**ALLEGHENY COUNTY SANITARY AUTHORITY**

**CONTRACT NO. 1735 G, E, H, P**

**ALCOSAN PARKING GARAGE**

**ADDENDUM NO. 2**

1 STAIR 2 - WEST ELEVATION  
A-51 SCALE: 3/16" = 1'-0"

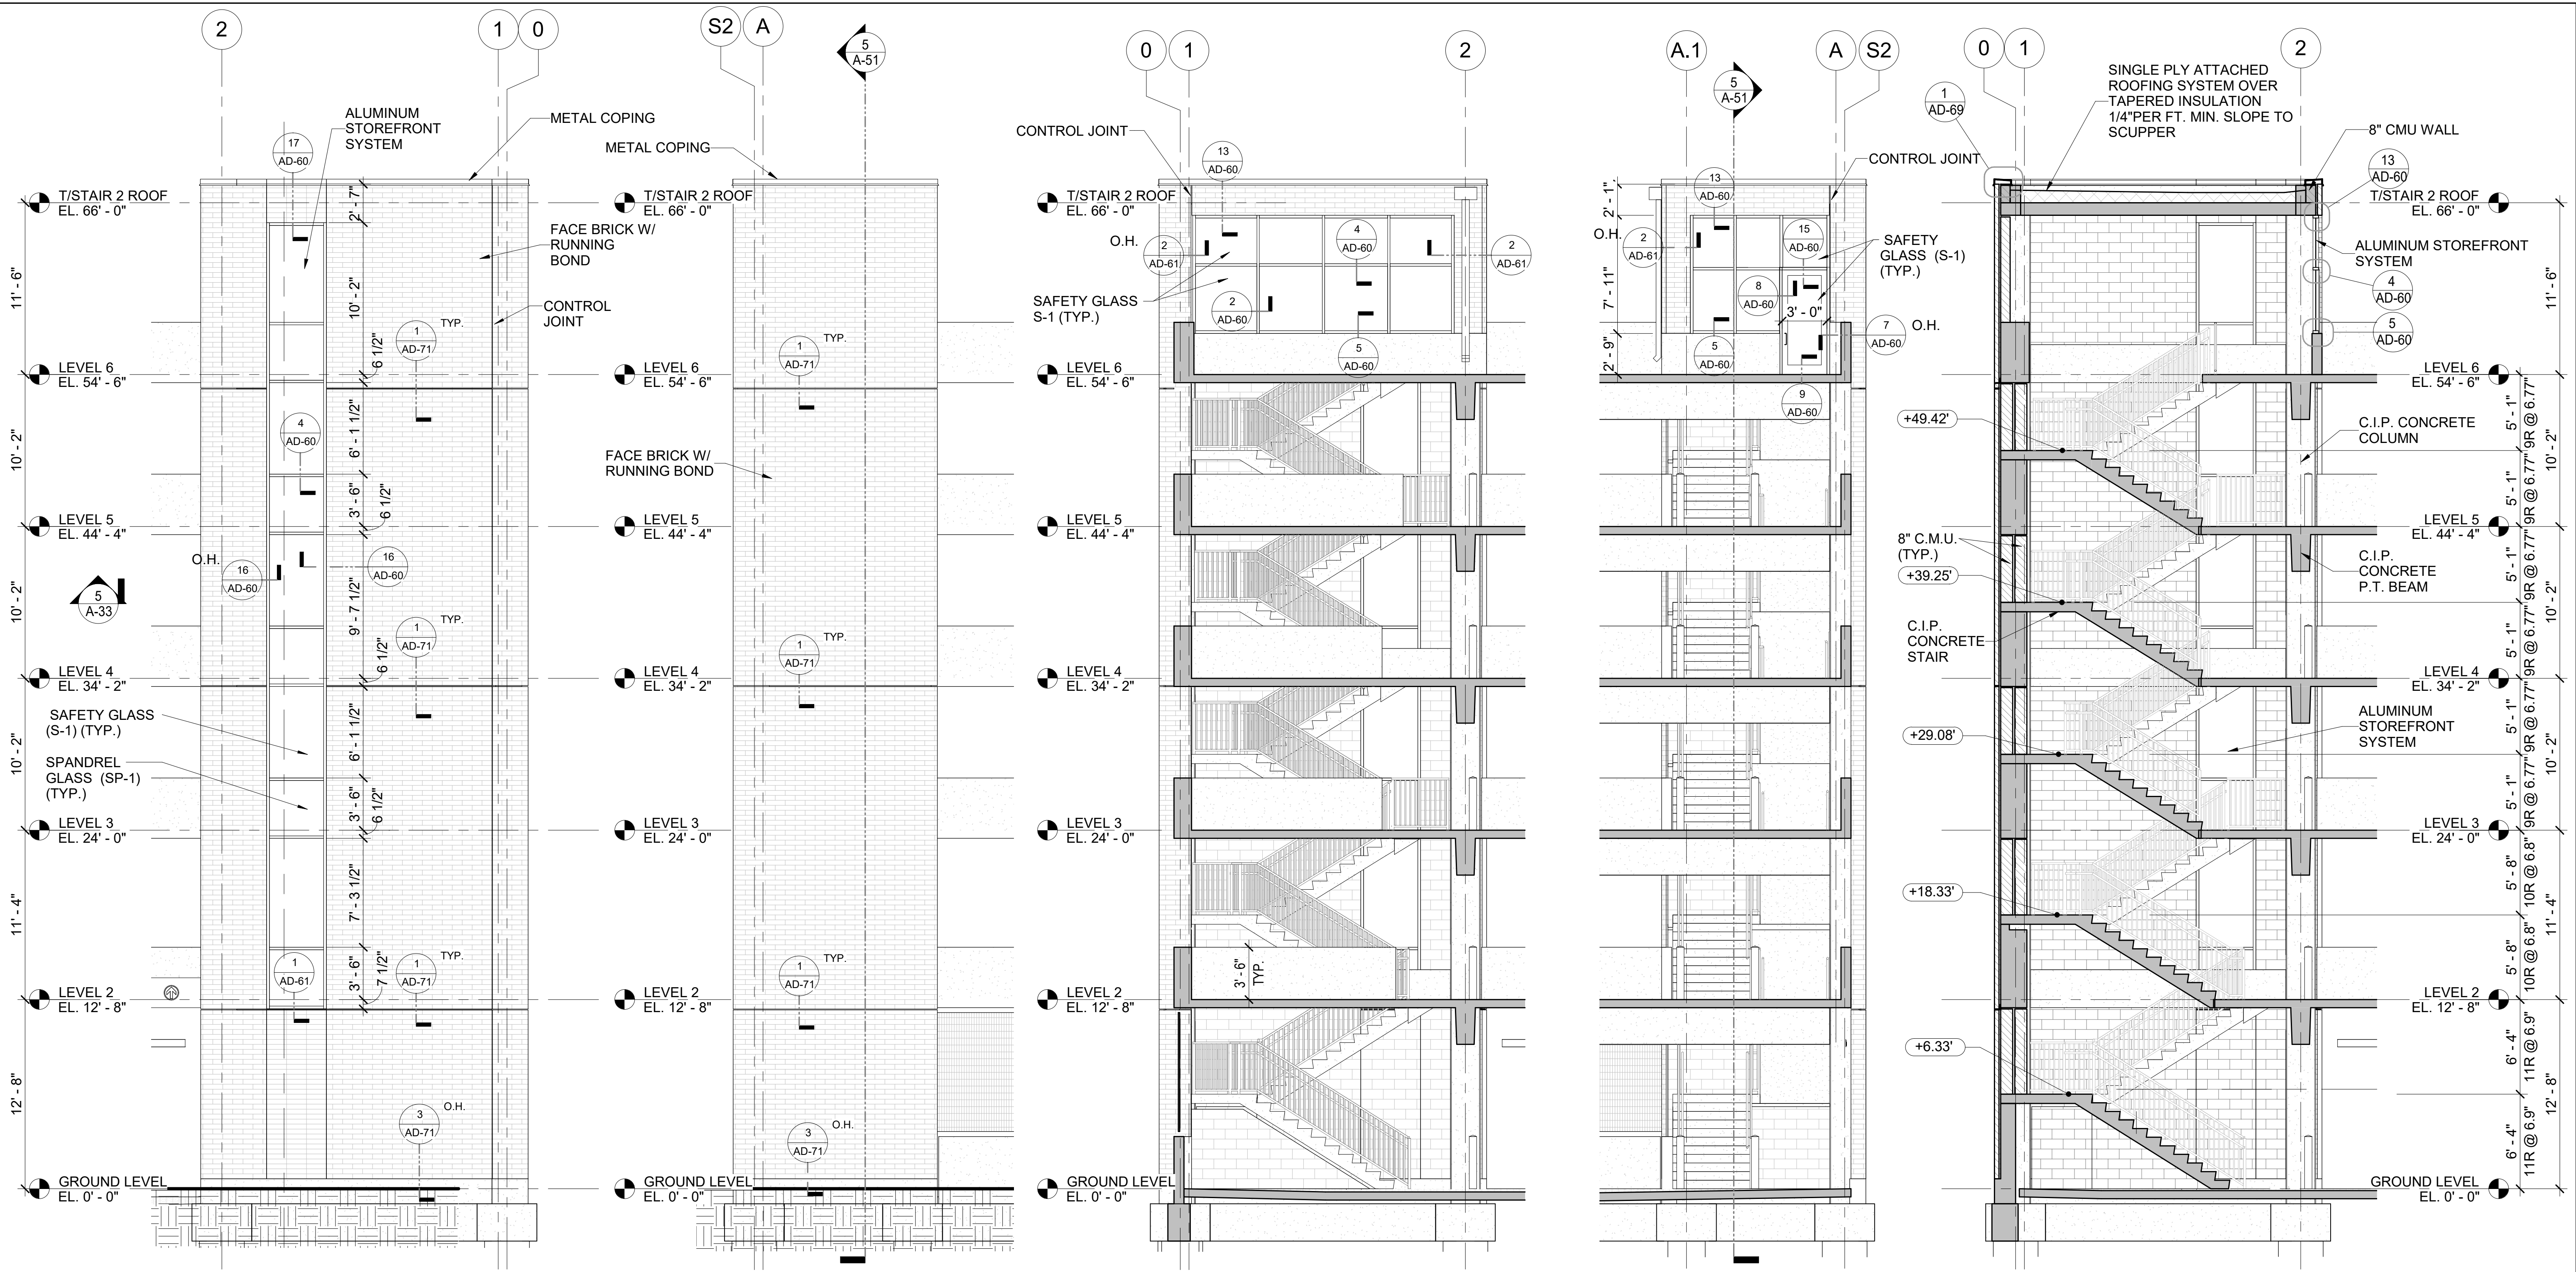
- a. REPLACE with the attached drawing 210-A-51.
  - b. Bar scale is corrected to agree with the elevations and section.
25. Drawing 210-AS-50 - Room/Door Schedule and Details

210-AD-62  
CURTAINWALL DETAILS - NON  
INSULATING GLAZING

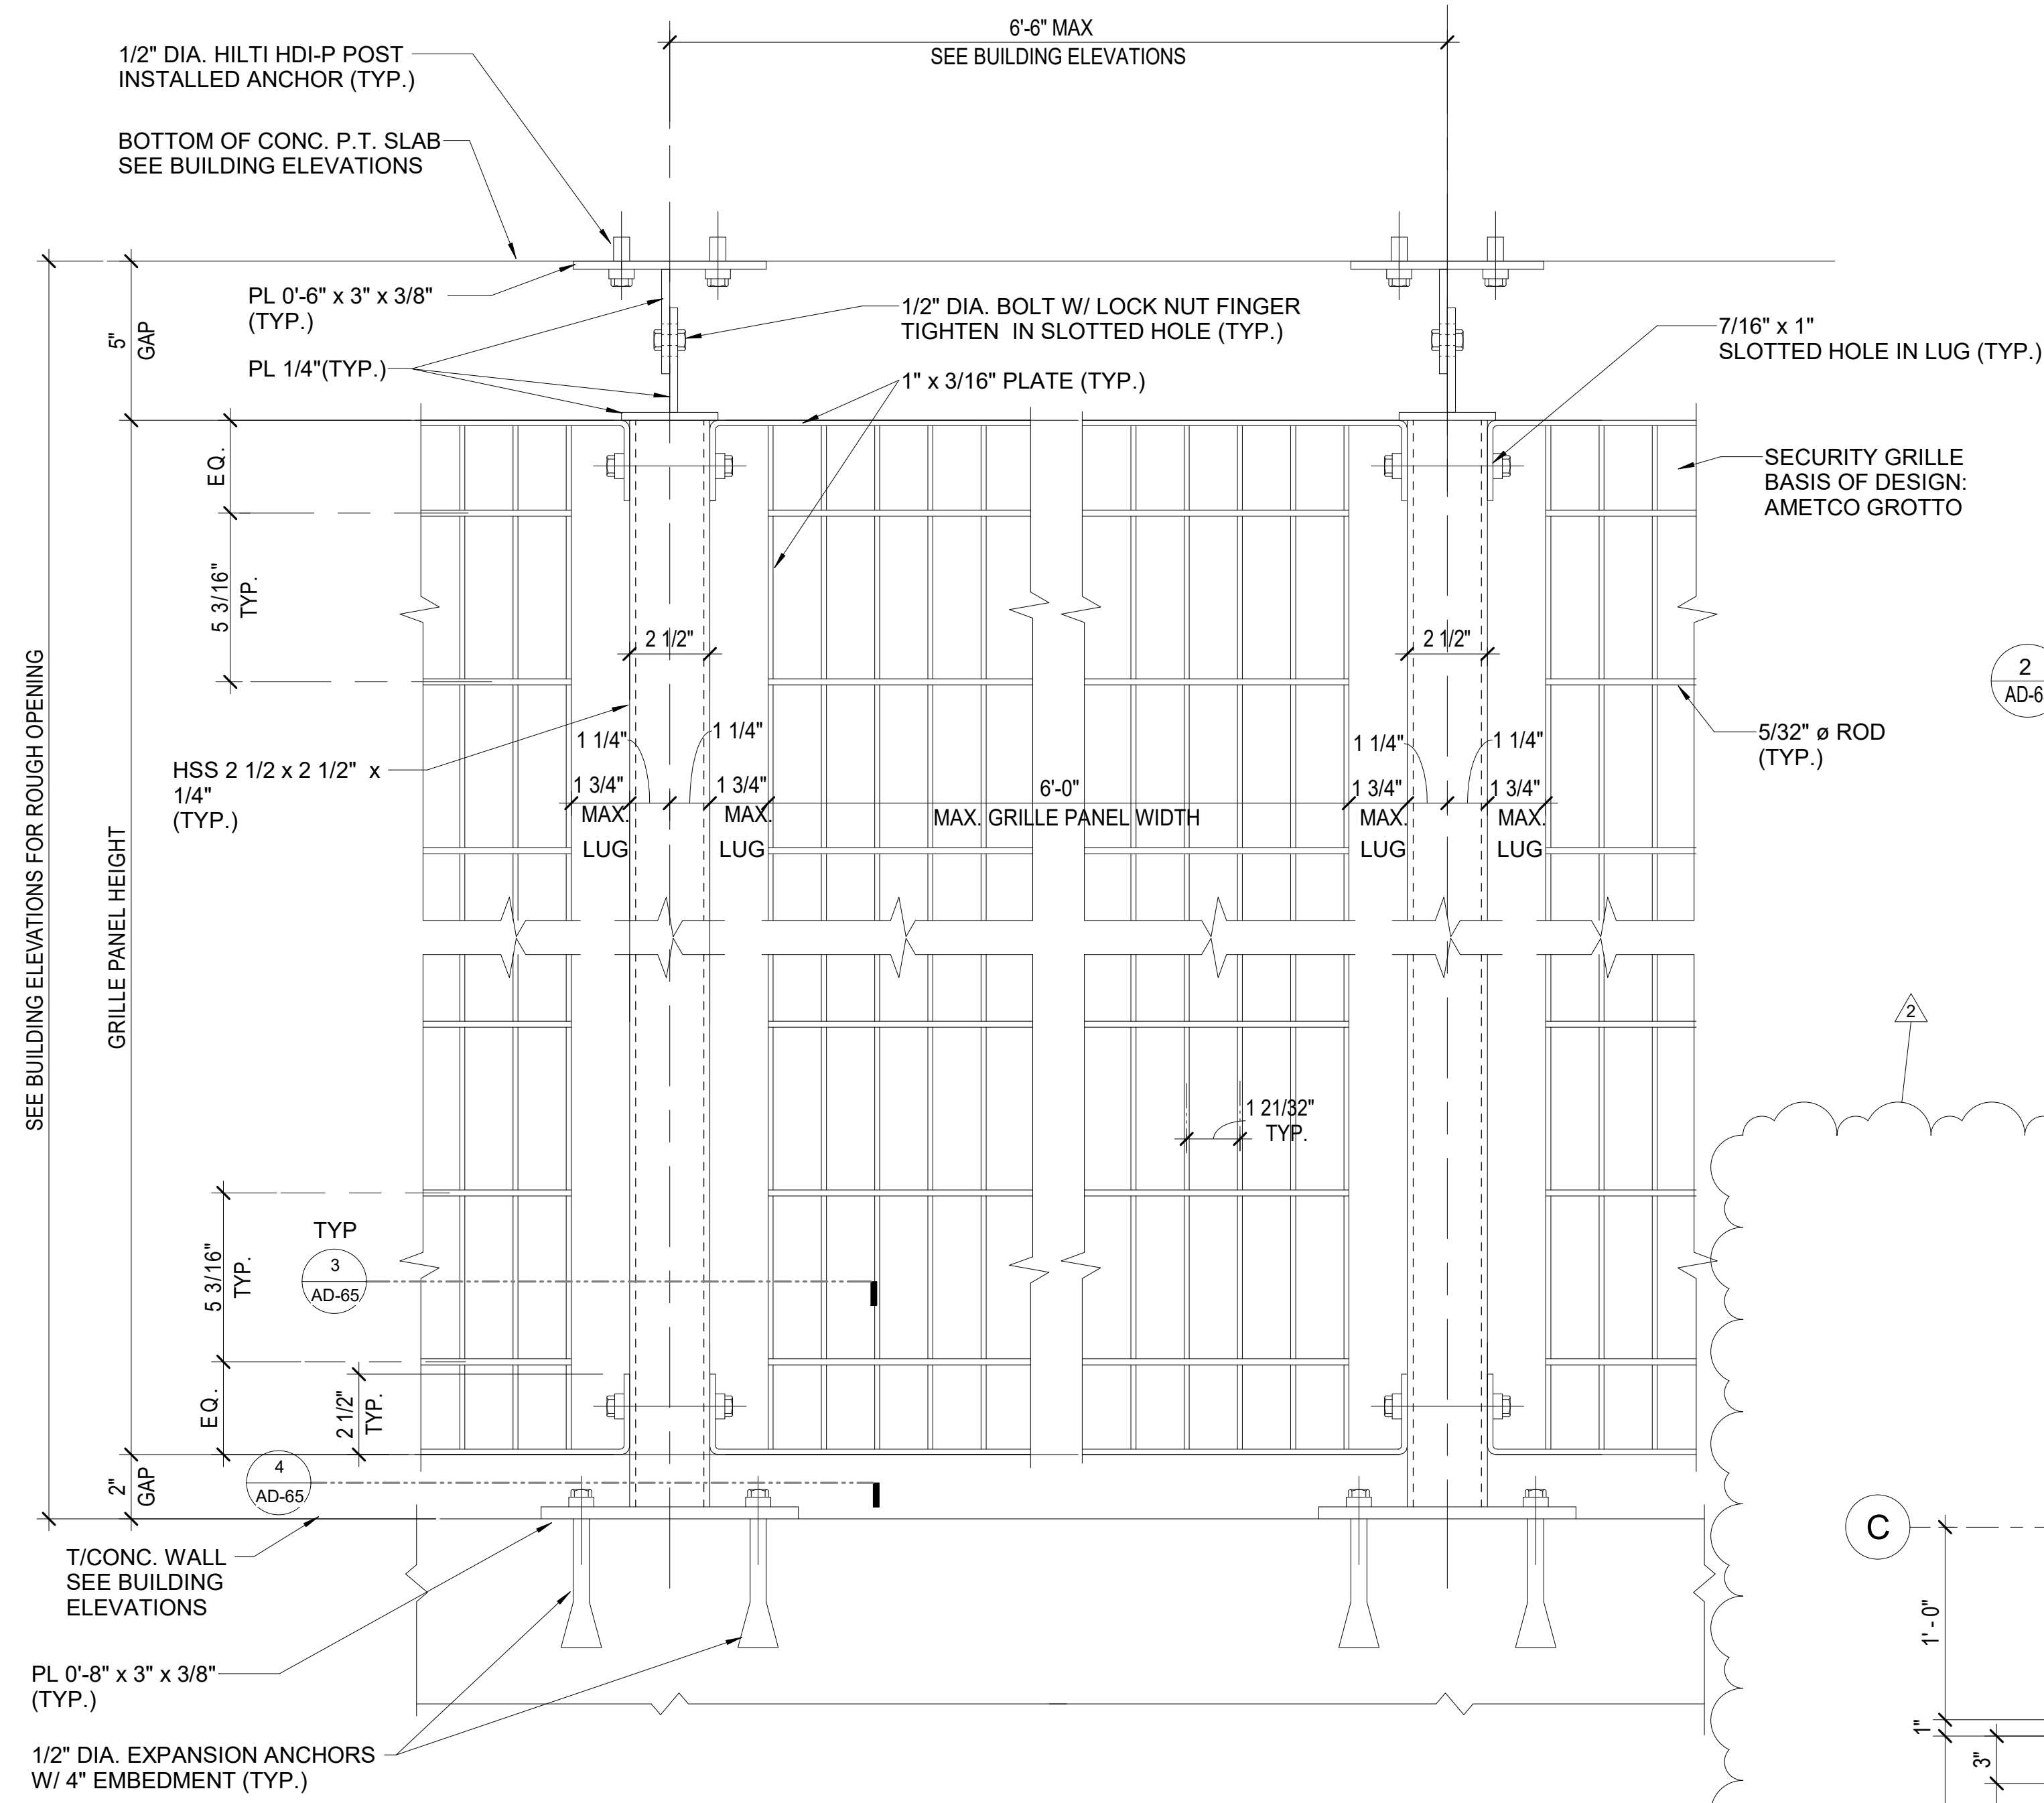
26. Drawing 210-AD-62 - Curtainwall Details-Non Insulating Glazing
  - a. REPLACE with the attached drawing 210-AD-62
  - b. Detail 10 is revised.
27. Drawing 210-A-65 - Security Grille Details

Q19: Detail 10/AD-62, what are the limits of the composite metal panels? Are they on the backside of the parapet, or does the TPO roofing come up that side? Are the composite panels on the horizontal top surface or does the TPO come across to a 'gravel stop' edge of some type?

1 GROUND LEVEL PLAN  
S-12 SCALE: 3/32" = 1'-0"

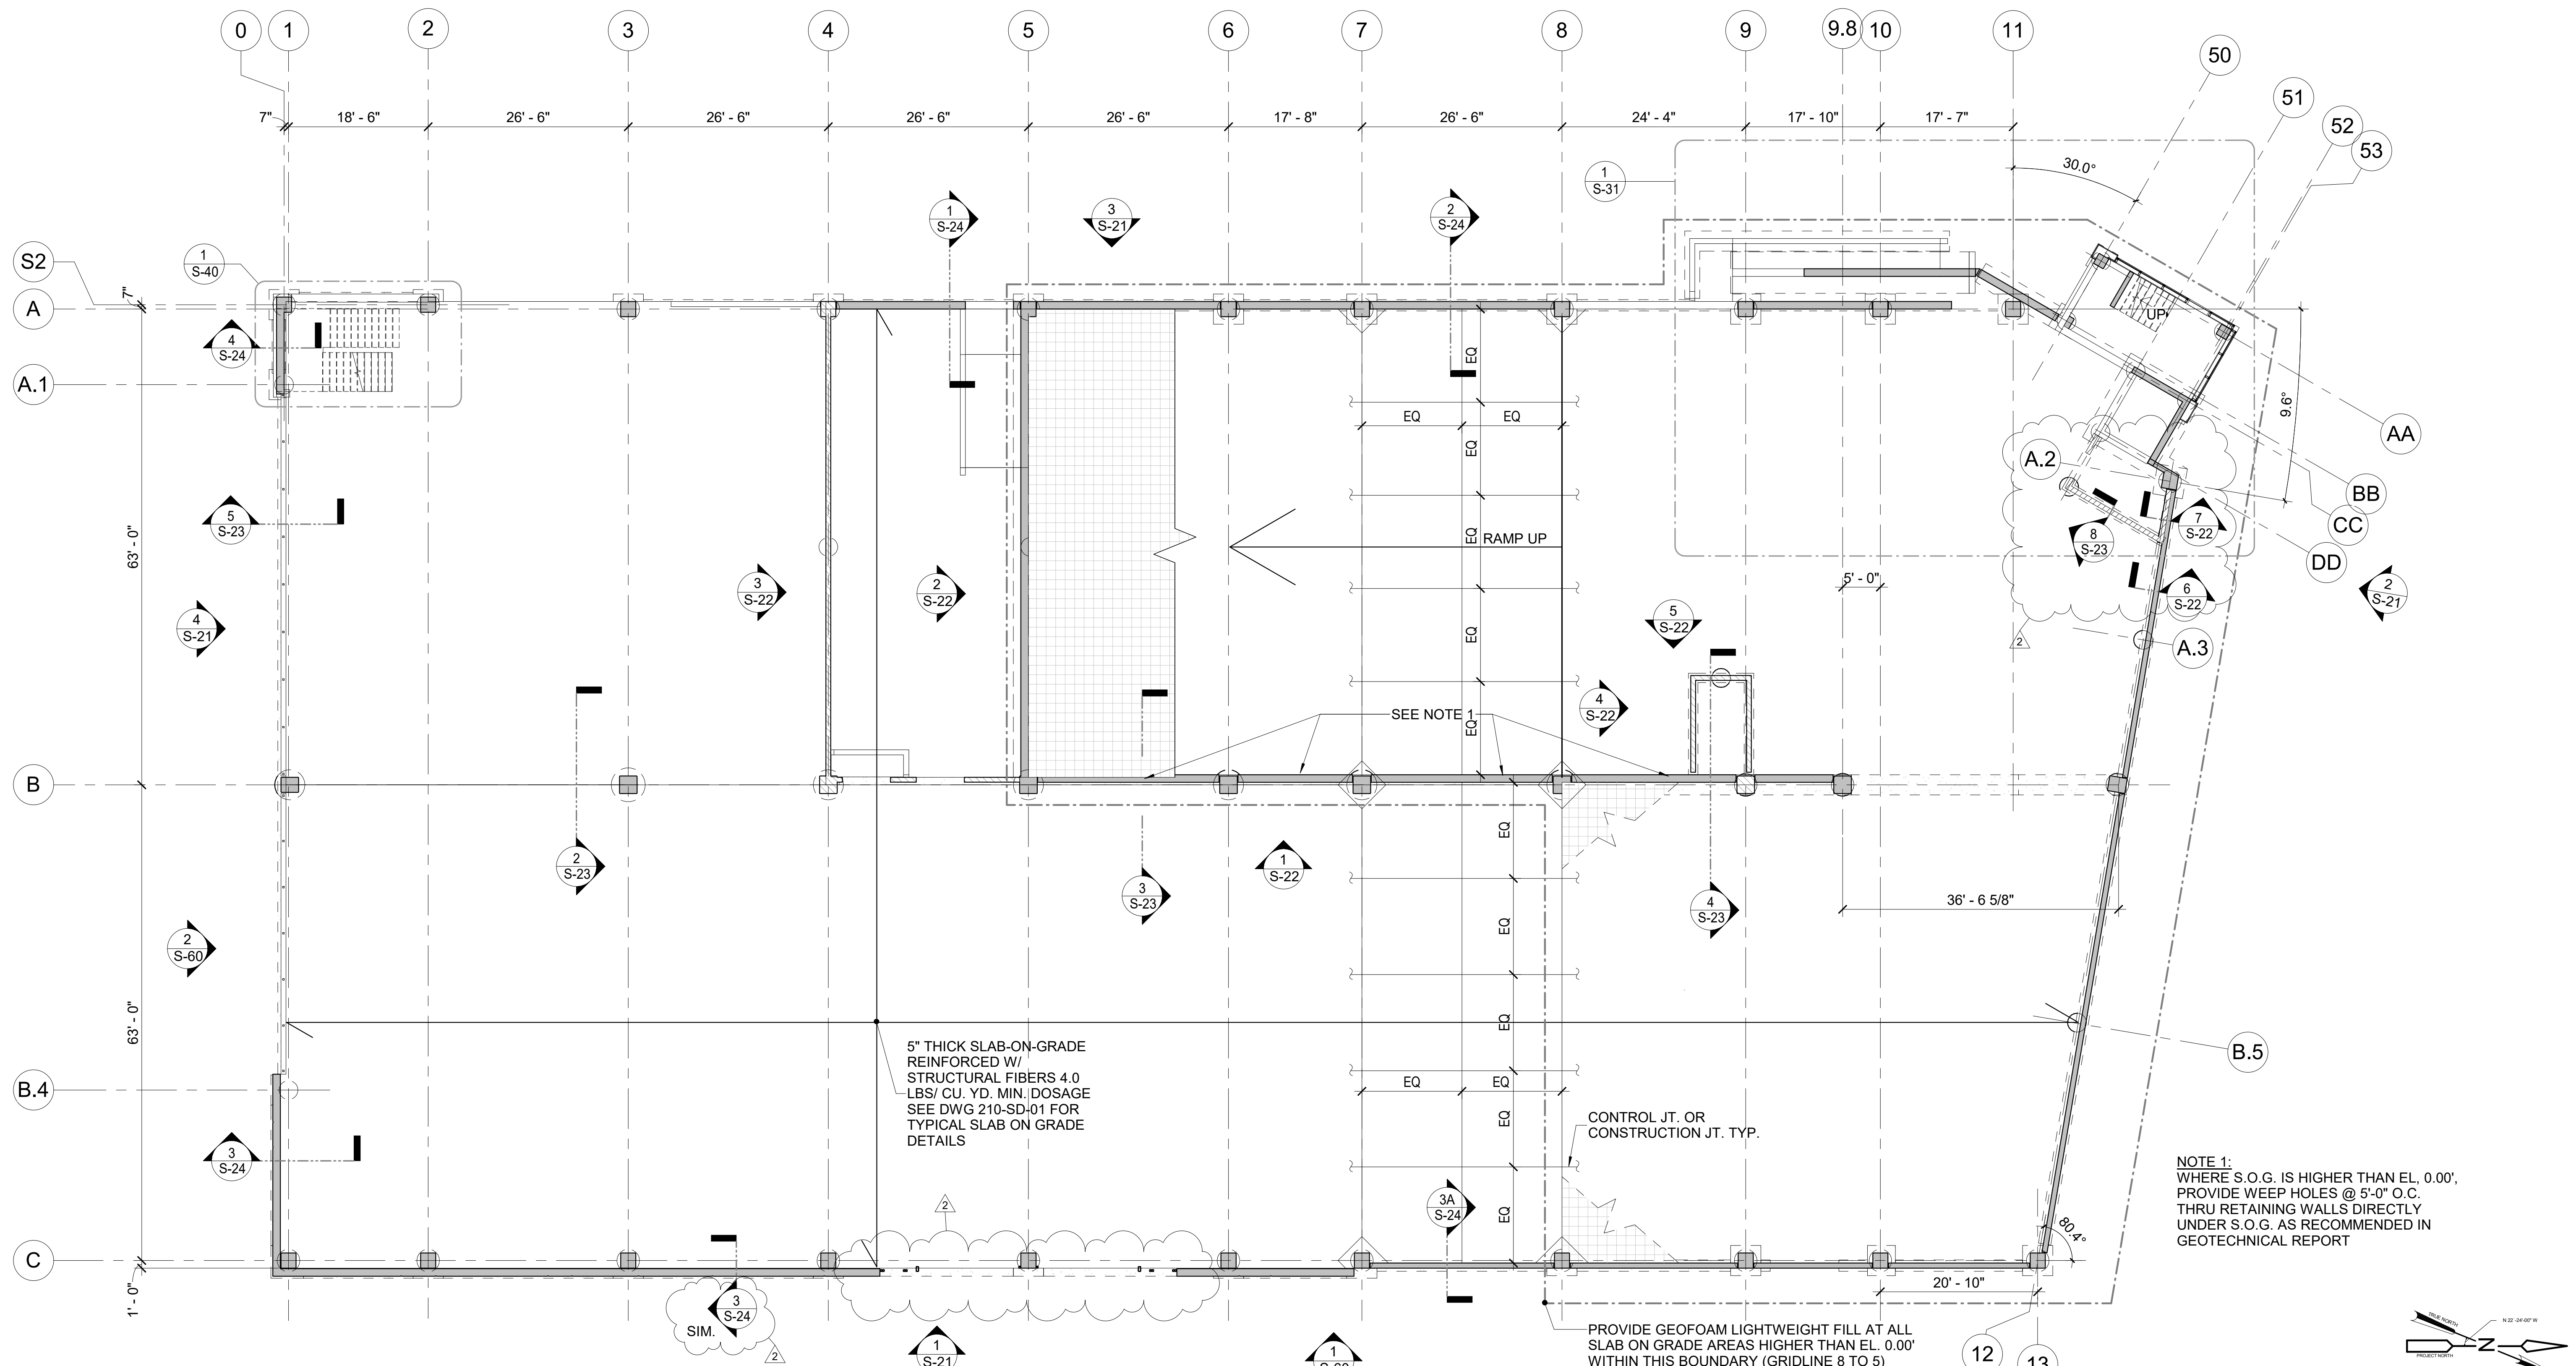
34. Drawing 210-S-12 - Ground Level Plan
  - a. REPLACE with the attached drawing 210-S-12.
  - b. Added a caisson on grid line 51 to support the elevator control room CMU wall.
  - c. Added a reference to section 8/210-S-23 to show the grade beam and caisson supporting the elevator control room CMU wall.
  - d. Section 3/210-S-24 has been revised to show an angle connection between the PT slab and CIP wall instead of the previous dowel connection.
  - e. Extended the grade beams between lines 4 and 6.

A11: Clarification is shown in Addendum 1 on drawing 210-S-12. Geofoam begins at gridline 8 in east bay and extends up to gridline 5 in west bay, as well as north end of building
